ADDENDUM TO  
SPECIFICATIONS ENTITLED  
"SPECIFICATIONS FOR  
WARDLAW COLLEGE ROOF REPLACEMENT  
STATE PROJECT NO. 50003317-2  
WARDLAW COLLEGE  
COLLEGE OF EDUCATION  
820 SOUTH MAIN STREET  
COLUMBIA, SOUTH CAROLINA"  
"

**ADDENDUM NO. 2**

**JULY 24, 2019**

1 WARDLAW COLLEGE ROOF PLAN  
SCALE: 1/16" = 1'-0"

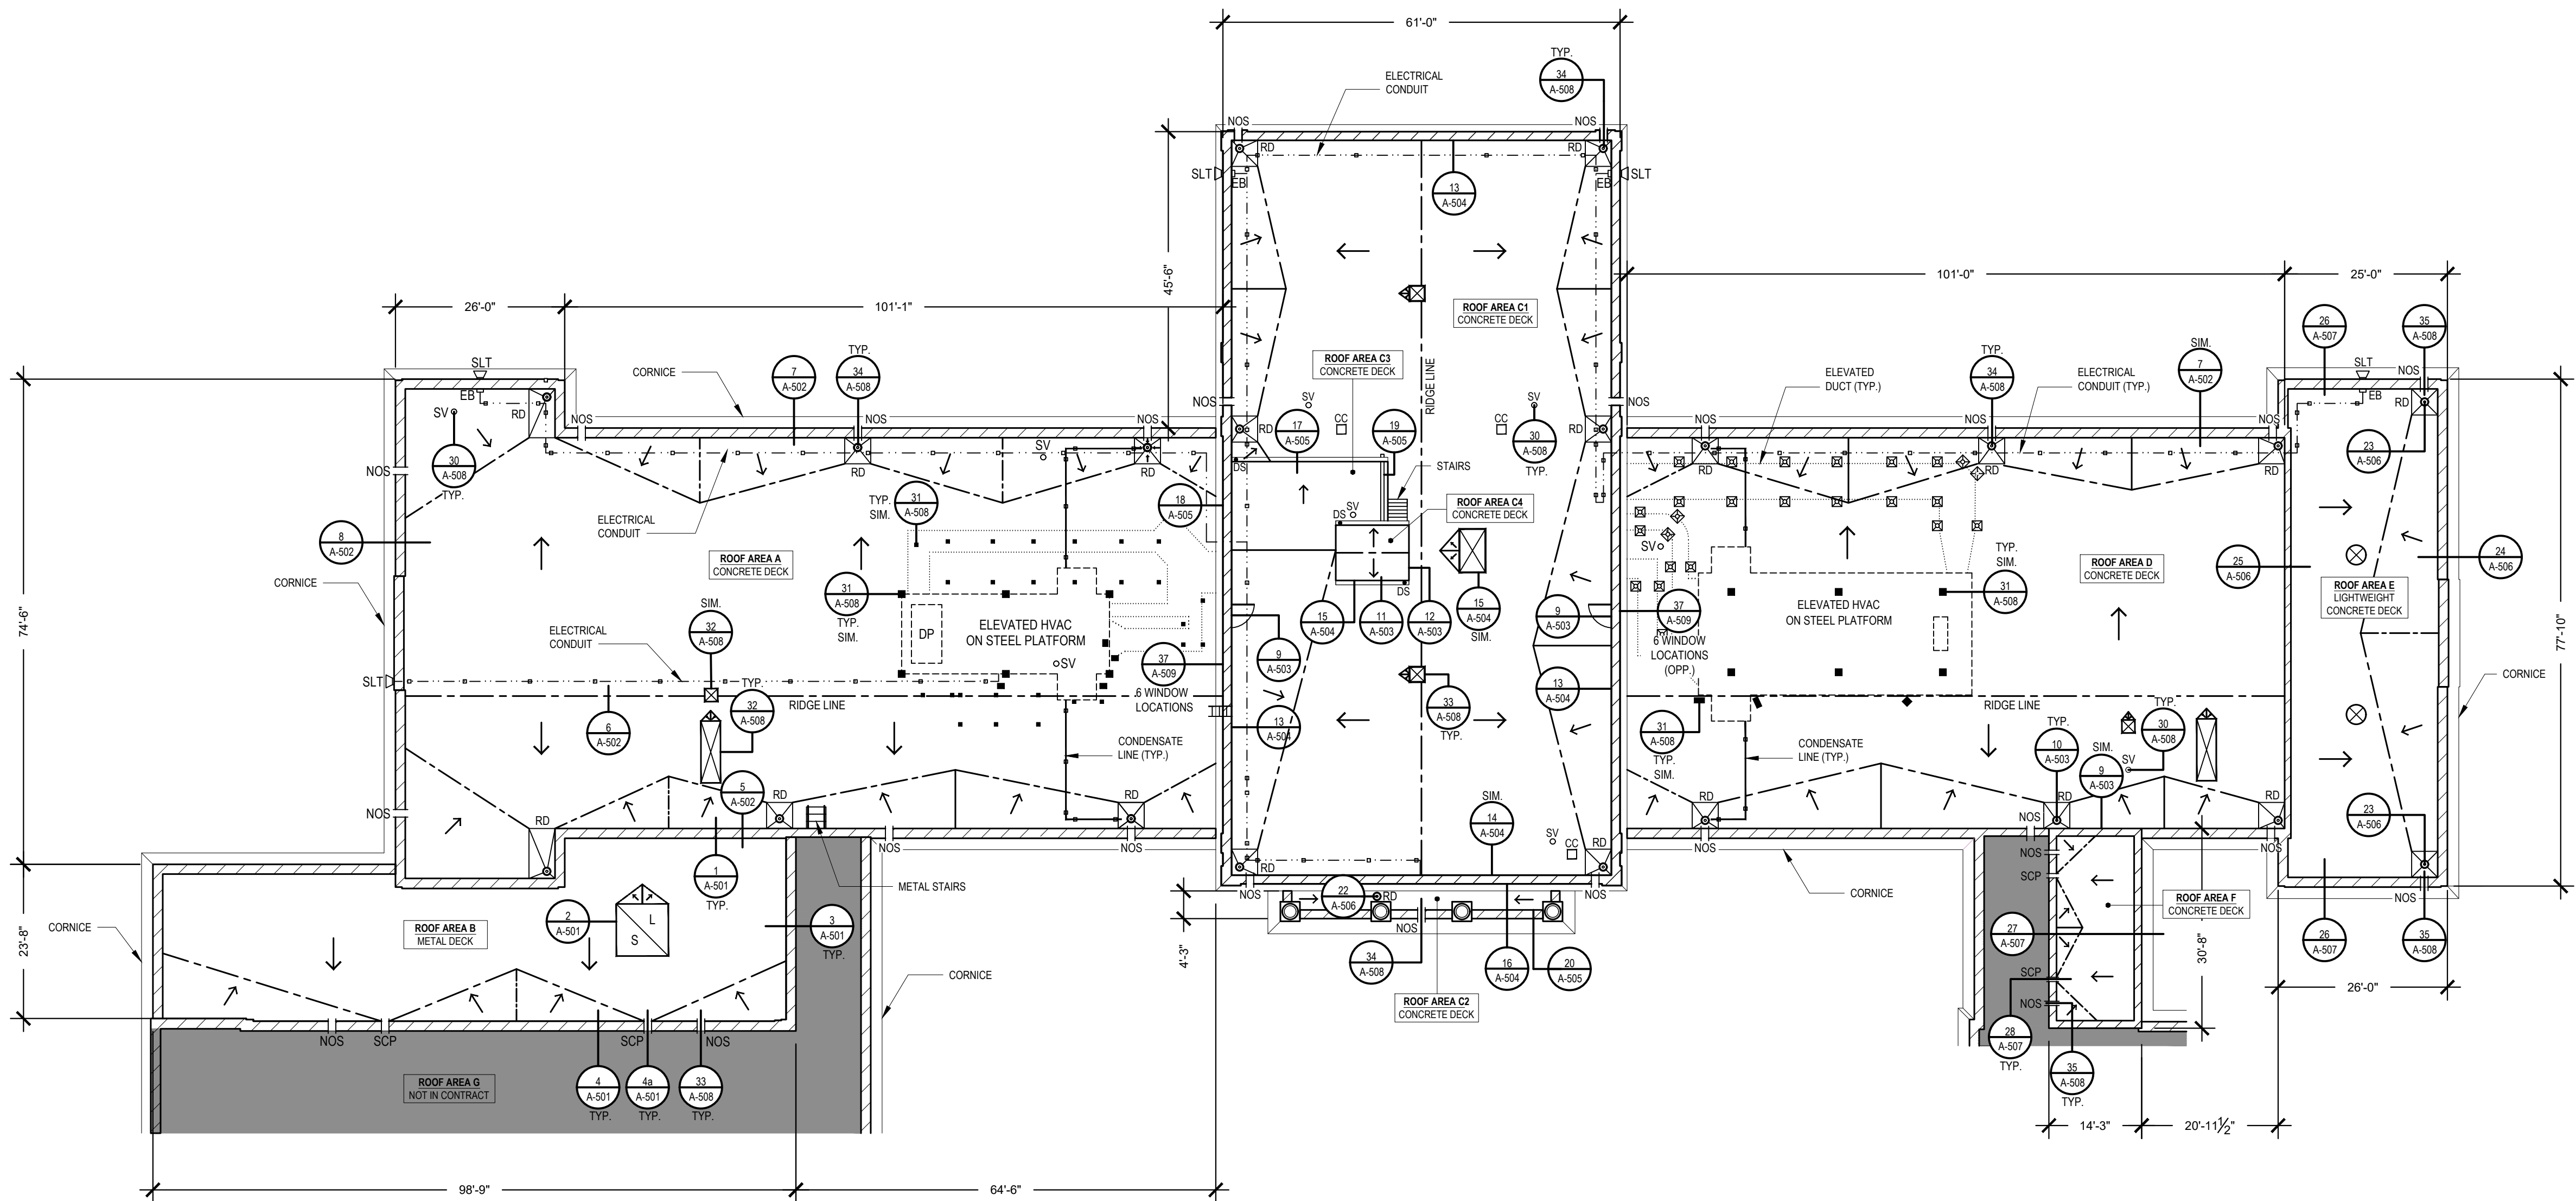
ADDENDUM:  
No.: DATE: DESCRIPTION:  
 7/23/19 ADDED WALKPAD REQUIREMENTS

- PROVIDE SUPPORTS FOR ALL CONDUIT, PIPES, AND CONDENSATION LINES. ALL SUPPORTS SHOULD BE SET ON WALKPADS.
- ON ANY ROOF AREA THAT A DOWNSPOUT IS TO BE INSTALLED, THE DOWNSPOUT SHOULD EXTEND TO THE NEAREST ROOF DRAIN AND BE SUPPORTED. SUPPORTS SHOULD BE INSTALLED OVER WALK PADS.

1 WARDLAW COLLEGE WALKPAD LAYOUT PLAN  
SCALE: 1/16" = 1'-0"

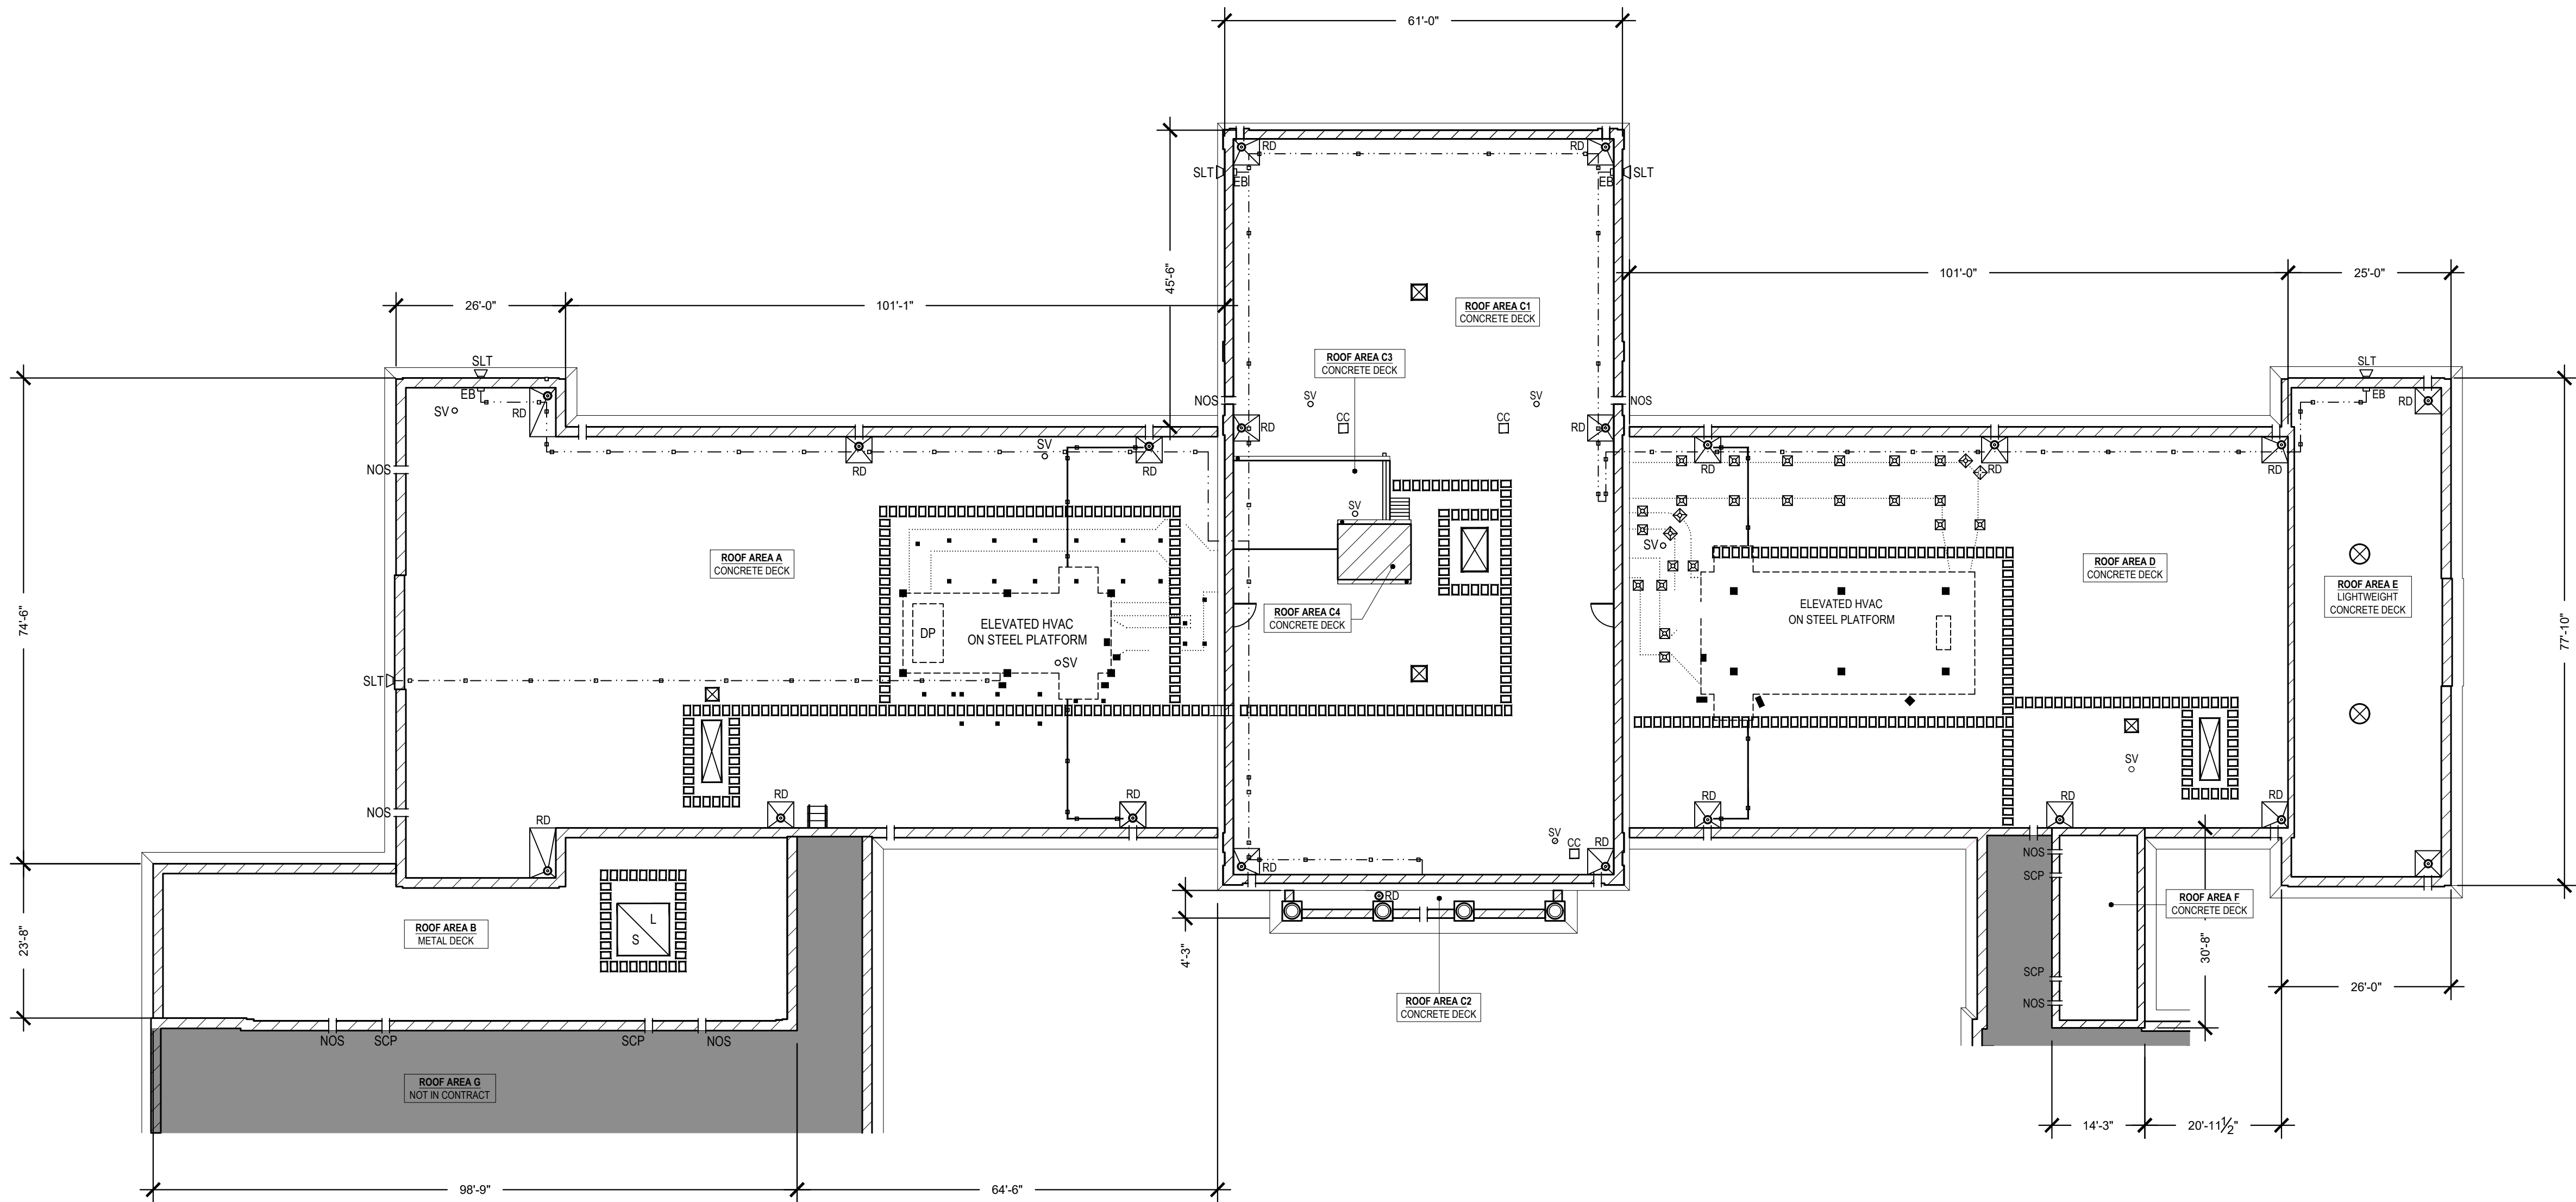
- PROVIDE SUPPORTS FOR ALL CONDUIT, PIPES, AND CONDENSATION LINES. ALL SUPPORTS SHOULD BE SET ON WALKPADS.
- ON ANY ROOF AREA THAT A DOWNSPOUT IS TO BE INSTALLED, THE DOWNSPOUT SHOULD EXTEND TO THE NEAREST ROOF DRAIN AND BE SUPPORTED. SUPPORTS SHOULD BE INSTALLED OVER WALKPADS.

No.: DATE: DESCRIPTION:  
1 7/23/19 ADDED WALKPAD REQUIREMENTS
